Product Change Notification

April 17, 2019

Bourns Announces Change to Housing of the Motorized Slide Potentiometer

Model PSP01 Series

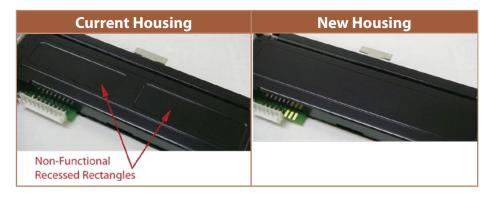
In the spirit of continuous improvement, effective July 15, 2019, Bourns is making a change in the stamping of the housing of the Model PSP01 Motorized Slide Potentiometer. Currently, there are two non-functional recessed rectangles measuring 51.8 mm wide x 13.7 mm high x 0.3 mm deep. This change will remove the non-functional recessed rectangles, resulting in ease of manufacturability of the product.

This change will not affect the function, quality or reliability of the product. The form will change due to the visible difference in the shape of the housing and the fit on the top will change slightly with the removal of the non-functional recessed rectangles. Products can be identified by the date code 1929. Below is a list of affected part numbers.
